BOARD OF TRUSTEES
REGULAR MEETING AGENDA

September 12, 2018
7:00 PM
151 Grant Avenue
Firestone, CO 80520

- 8.a. Proposed Final Plat and Final Development Plan for Cottonwood Hollow, F1
Resolution 18-31: A RESOLUTION APPROVING A FINAL PLAT AND FINAL DEVELOPMENT PLAN FOR COTTONWOOD HOLLOW, FILING 1
- 8.b. Proposed Revised Final Development Plan for Phase 2 of Gateway North-Multi Family
RESOLUTION 18-33: A RESOLUTION APPROVING A FINAL DEVELOPMENT PLAN FOR GATEWAY NORTH - MULTI-FAMILY (PHASE 2)
- 8.c. Proposed Final Plats and Final Development Plan for St Vrain Ranch Subdivision F3A and St Vrain Ranch Subdivision F5A
Resolution 18-34: A RESOLUTION APPROVING FINAL PLATS AND FINAL DEVELOPMENT PLANS FOR ST VRAIN RANCH FILINGS 3A AND 5A

UTILITY PLAN

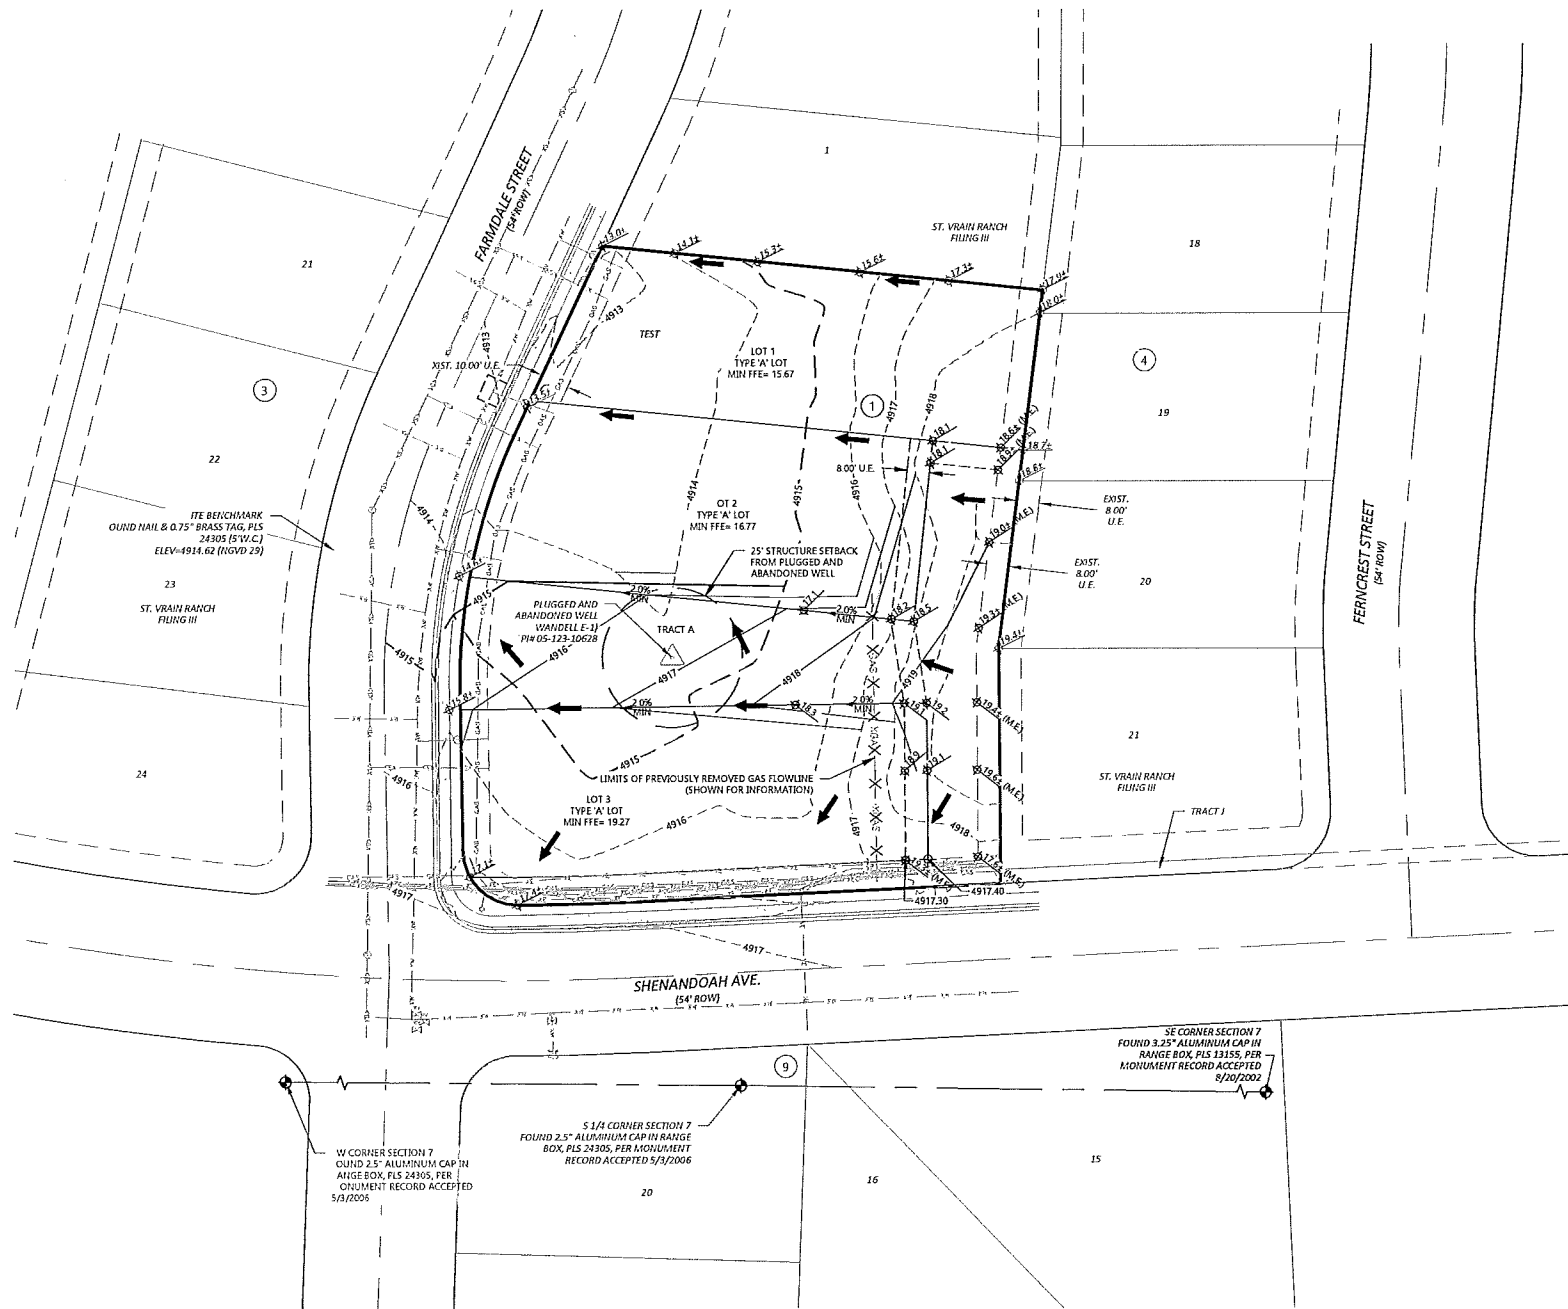
FDP Filings 3A and 5A Sheet 3 (Utility Plan)

FDP Filing 3A Sheet 3 (Utility Plan)

A REPLAT OF TRACT D, ST. VRAIN RANCH SUBDIVISION, FILING III,
LOCATED IN THE SOUTHEAST 1/4 OF SECTION 7,
TOWNSHIP 2 NORTH, RANGE 67 WEST OF THE 6TH P.M.,
TOWN OF FIRESTONE, COUNTY OF WELD, STATE OF COLORADO
SHEET 2 OF 2

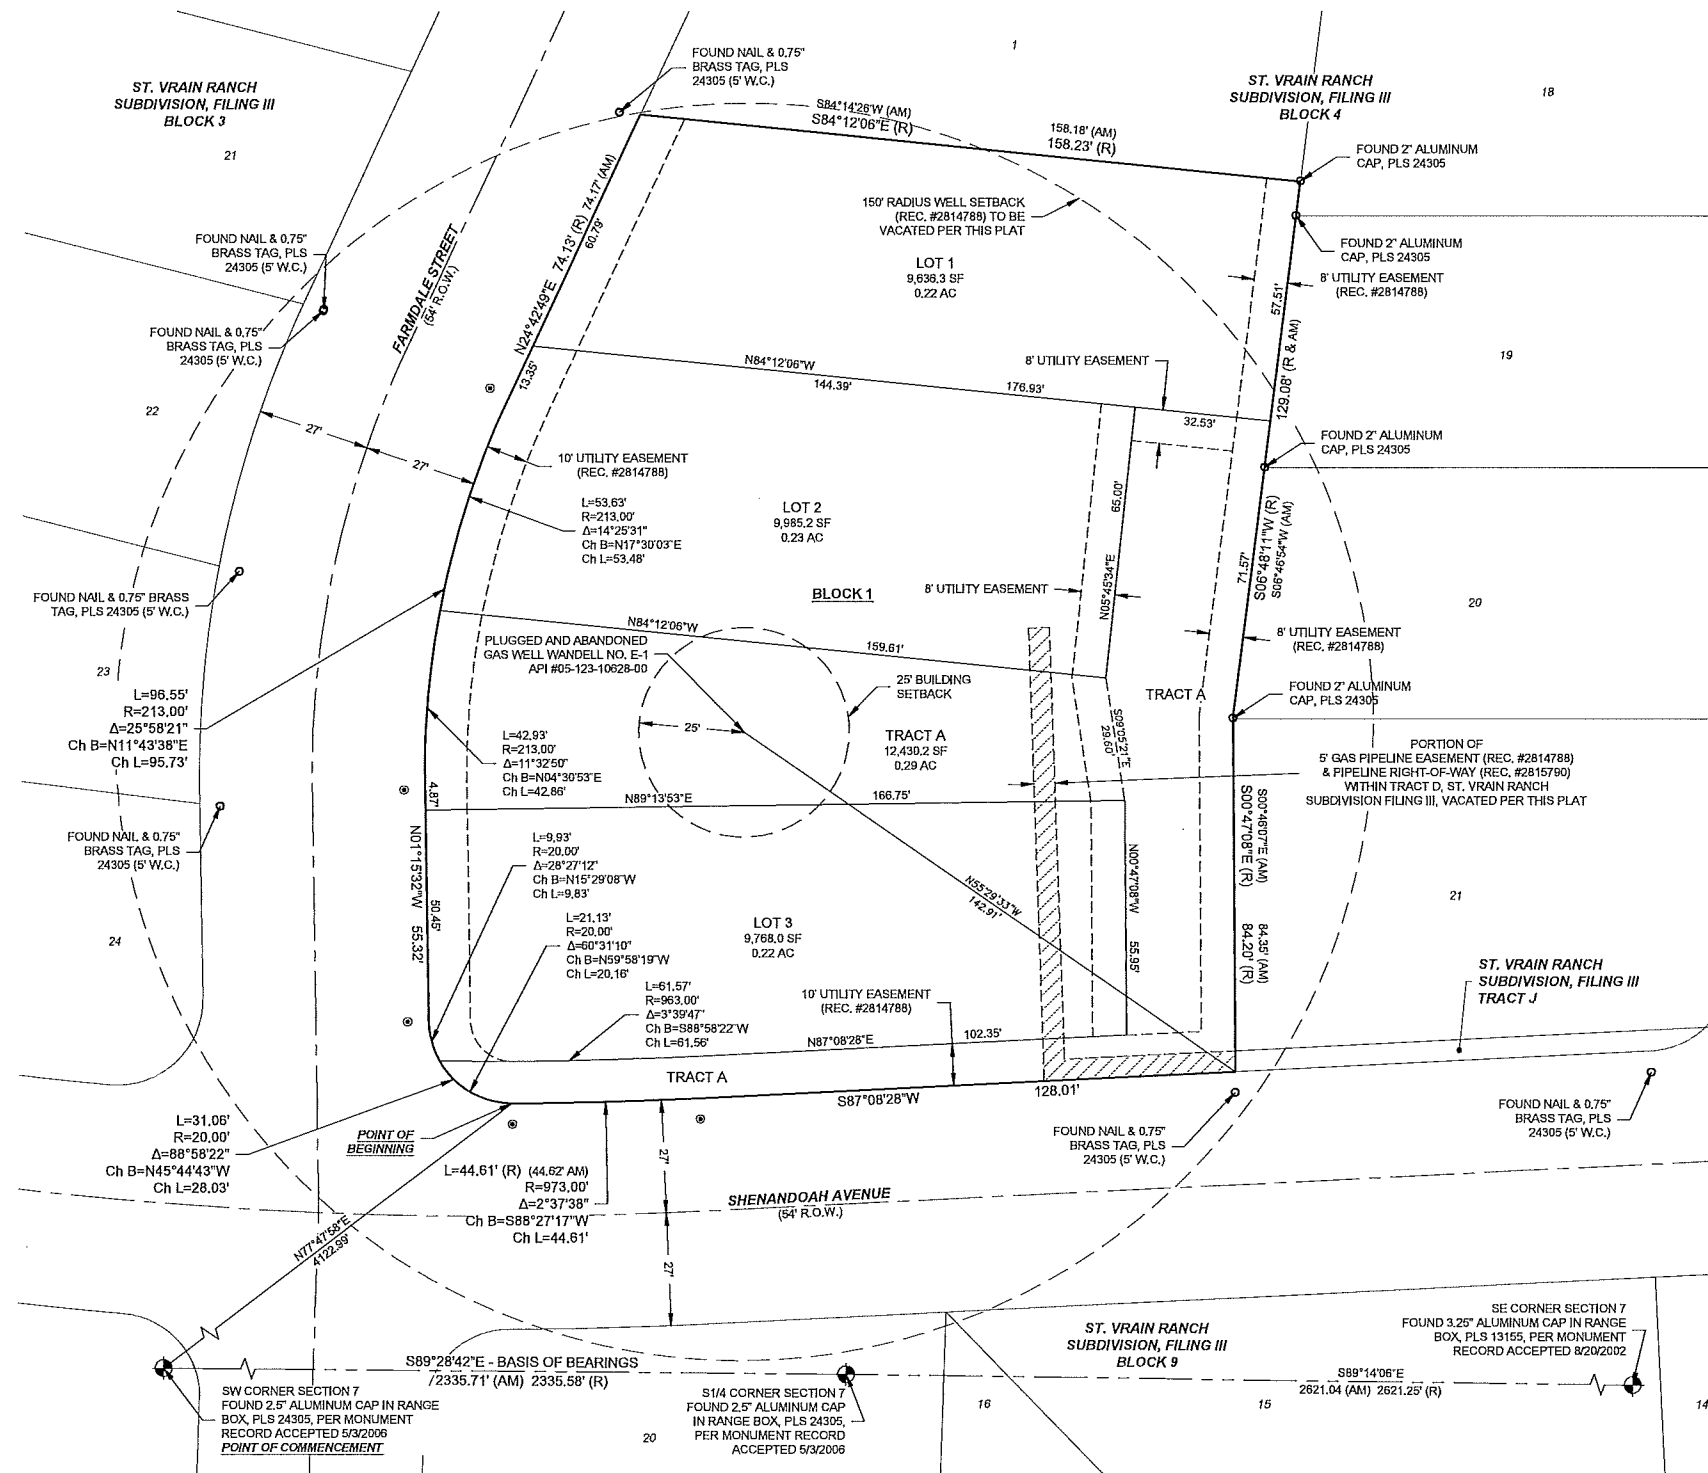
3. On Sheet 2, correct the recorded reference to Filing III instead of Filing V.
4. On Sheet 2, add side lot easements for the Tract A drainage.
5. On Sheet 2, revise the Note to read “No building structures. . . .” as shown on the Town Engineer’s redlines. Label the cap elevation for the plugged and abandoned well.
6. Revise the plat to address Town Engineer redlines.

7. On Sheet 2, add side lot drainage easements for each of the lots and Tract A.
8. On Sheet 2, revise the Note to read “No building structures. . . .” as shown on the Town Engineer’s redlines. Label the cap elevation for the plugged and abandoned well.
9. Revise the plat to address Town Engineer redlines.
